ADDENDUM NO. 3

**RE: NCDAC NC Correctional Institution for Women
Air Conditioning Installation
SCO ID#: 22-24913-02A
NCDAC Central Engineering Job Order # 4290**

DATE: September 12, 2023

MECHANICAL - CONTROLS

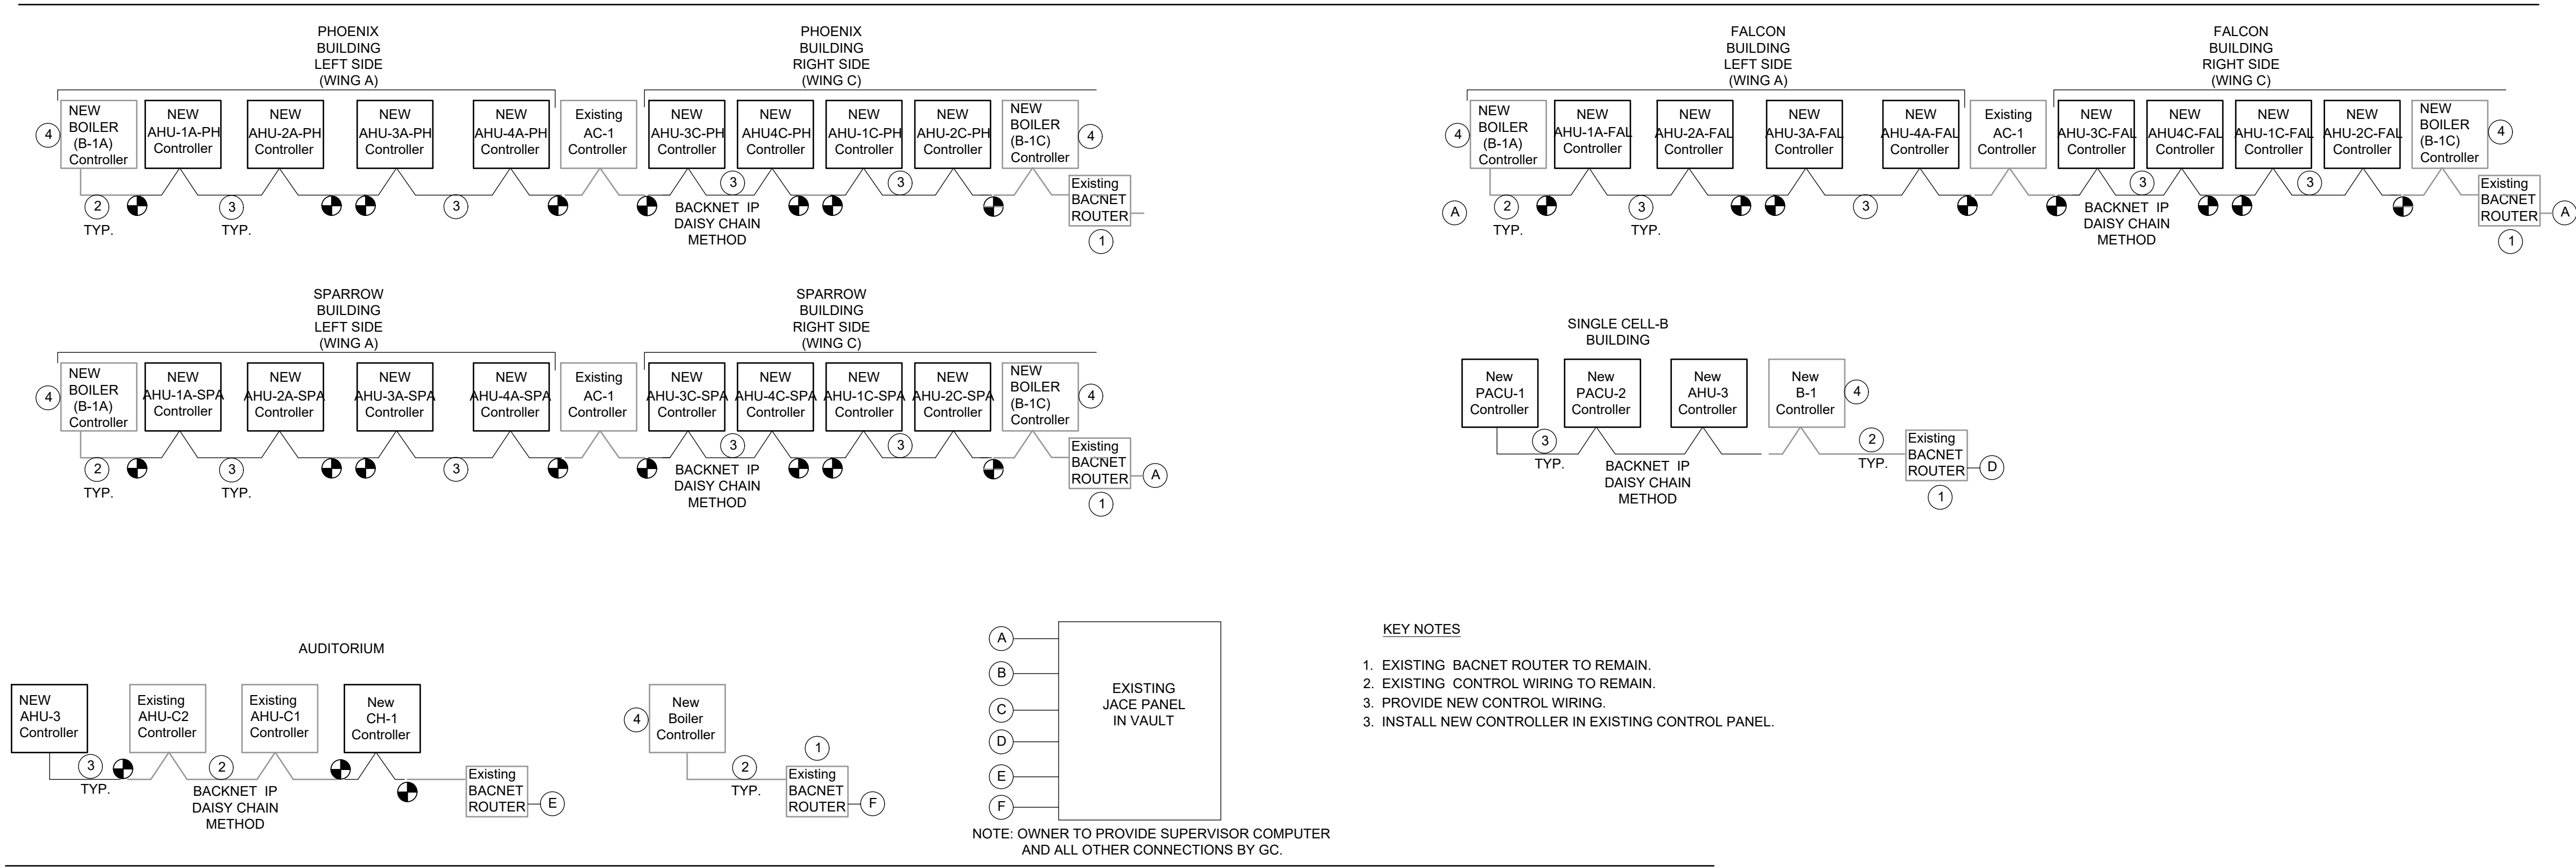
9. Sheet M600: Revise sequence of operation. See revisions on attached sheet.
10. Sheet M601: Revise detail 2. See revisions on attached sheet.
11. Sheet M602: See revisions on attached sheet.

NOTE:
 THE NEW AHUS (TYP. OF 24) ARE TO BE PROVIDED WITH VFDs FOR FAN SPEED CONTROL. THESE AHUS ARE INTENDED TO OPERATE AT TWO (2) DISTINCT AIRFLOW RATES:
 - "HIGH" SHALL CORRESPOND TO THE FAN SPEED REQUIRED TO DELIVER 5625 CFM.
 - "LOW" SHALL CORRESPOND TO THE FAN SPEED REQUIRED TO DELIVER 3800 CFM.

TAB CONTRACTOR SHALL TEST EACH SYSTEM TO DETERMINE THE BAS VFD SPEED COMMAND (%) NECESSARY FOR EACH SYSTEM TO DELIVER THESE SPECIFIC AIR FLOWS AND RECORD IN TAB REPORT. BAS CONTRACTOR SHALL PROVIDE AN ENGRAVED PHOENIX PLACARD (MIN. 3"8" LETTERING) AT EACH AHU/VFD INDICATING THIS INFORMATION, AND SHALL UTILIZE THE INFORMATION IN PROGRAMMING THE "HIGH" AND "LOW" BAS SPEED COMMANDS AS DESCRIBED IN THESE DRAWINGS.

1 FIRE ALARM SMOKE CONTROL INTERFACE CONTROL DETAIL (TYPICAL FOR SPARROW , FALCON AND PHONEIX BUILDING)
NOT TO SCALE

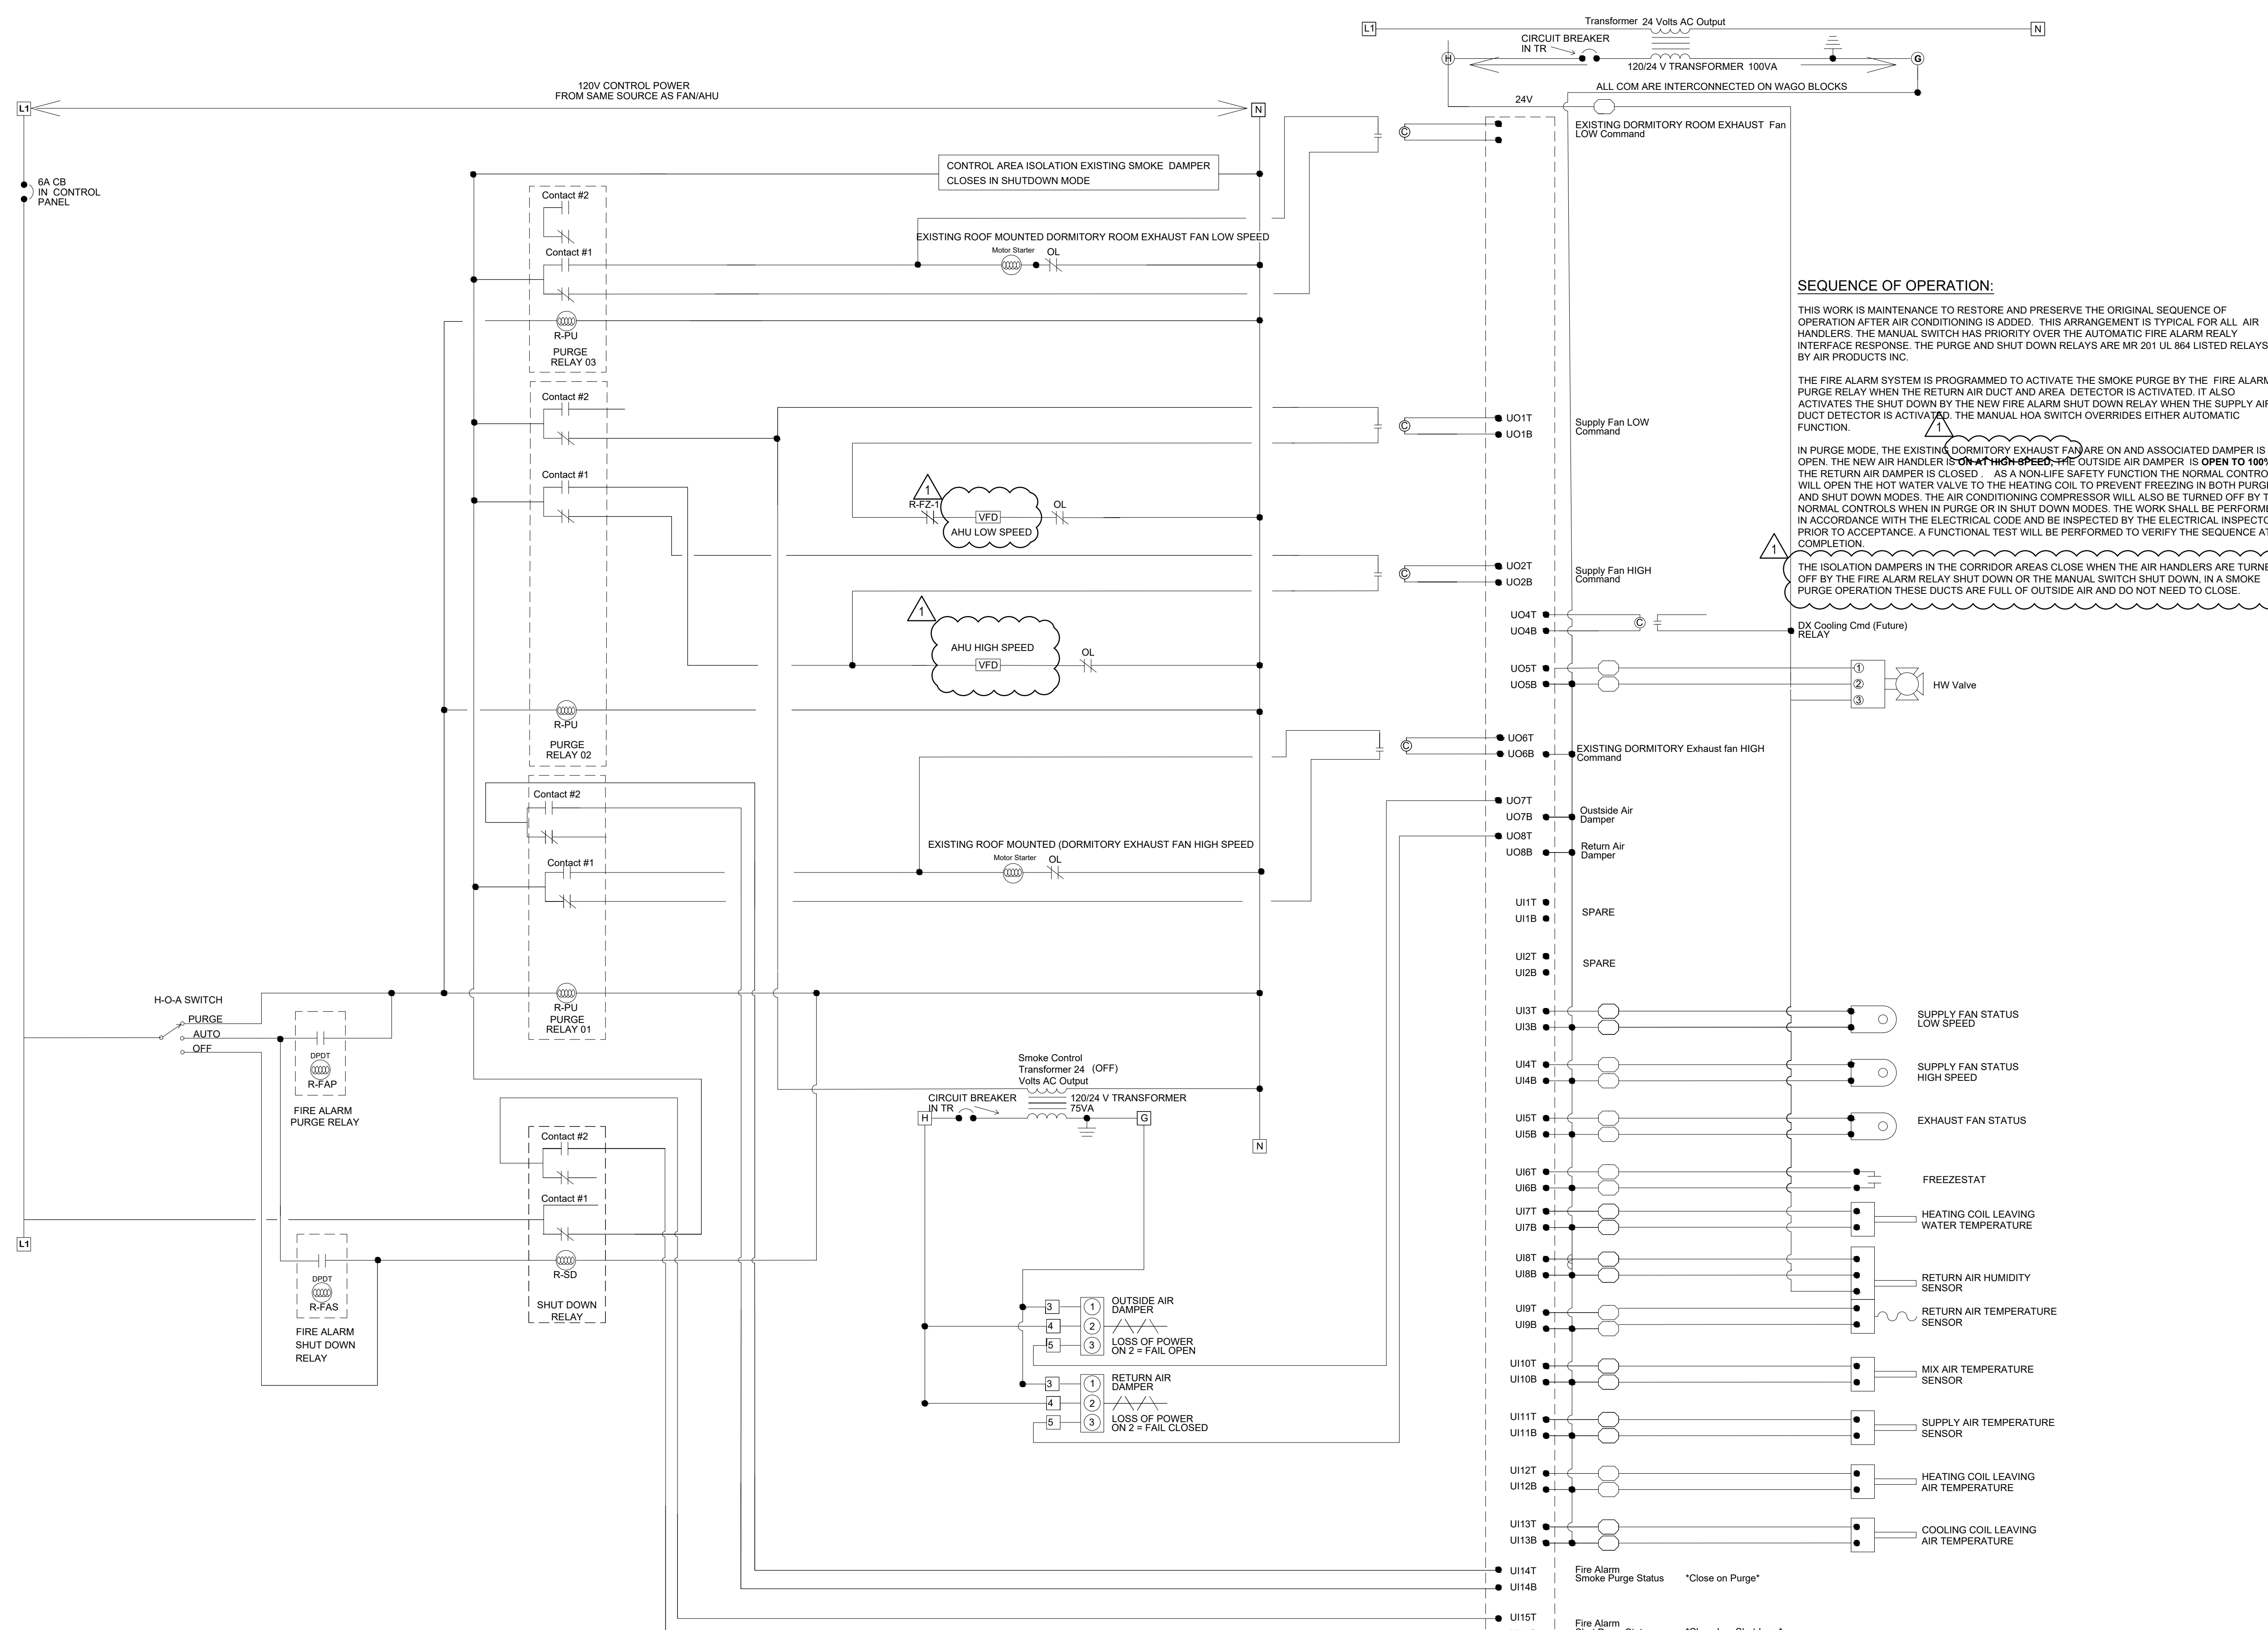
12. Sheet M603: Revise sequence of operation. See revisions on attached sheet.
13. Sheet M604: Revise sequence of operation. See revisions on attached sheet.

THIS WORK IS MAINTENANCE TO RESTORE AND PRESERVE THE ORIGINAL SEQUENCE OF OPERATION AFTER AIR CONDITIONING IS ADDED. THIS ARRANGEMENT IS TYPICAL FOR ALL AIR HANDLERS. THE MANUAL SWITCH HAS PRIORITY OVER THE AUTOMATIC FIRE ALARM RELAY INTERFACE RESPONSE. THE PURGE AND SHUT DOWN RELAYS ARE MR 201 UL 864 LISTED RELAYS BY AIR PRODUCTS INC.

THE FIRE ALARM SYSTEM IS PROGRAMMED TO ACTIVATE THE SMOKE PURGE BY THE FIRE ALARM PURGE RELAY WHEN THE RETURN AIR DUCT AND AREA DETECTOR IS ACTIVATED. IT ALSO ACTIVATES THE SHUT DOWN BY THE NEW FIRE ALARM SHUT DOWN RELAY WHEN THE SUPPLY AIR DUCT DETECTOR IS ACTIVATED. THE MANUAL HOA SWITCH OVERRIDES EITHER AUTOMATIC FUNCTION.

IN PURGE MODE, THE EXISTING DORMITORY EXHAUST FAN ARE ON AND ASSOCIATED DAMPER IS OPEN. THE NEW AIR HANDLER IS ON AT HIGH SPEED. THE OUTSIDE AIR DAMPER IS OPEN TO 100%, THE RETURN AIR DAMPER IS CLOSED. AS A NON-LIFE SAFETY FUNCTION THE NORMAL CONTROLS WILL OPEN THE HOT WATER VALVE TO THE HEATING COIL TO PREVENT FREEZING IN BOTH PURGE AND SHUT DOWN MODES. THE AIR CONDITIONING COMPRESSOR WILL ALSO BE TURNED OFF BY THE NORMAL CONTROLS WHEN IN PURGE OR IN SHUT DOWN MODES. THE WORK SHALL BE PERFORMED IN ACCORDANCE WITH THE ELECTRICAL CODE AND BE INSPECTED BY THE ELECTRICAL INSPECTOR PRIOR TO ACCEPTANCE. A FUNCTIONAL TEST WILL BE PERFORMED TO VERIFY THE SEQUENCE AT COMPLETION.

THE ISOLATION DAMPERS IN THE CORRIDOR AREAS CLOSE WHEN THE AIR HANDLERS ARE TURNED OFF BY THE FIRE ALARM RELAY SHUT DOWN OR THE MANUAL SWITCH SHUT DOWN. IN A SMOKE PURGE OPERATION THESE DUCTS ARE FULL OF OUTSIDE AIR AND DO NOT NEED TO CLOSE.
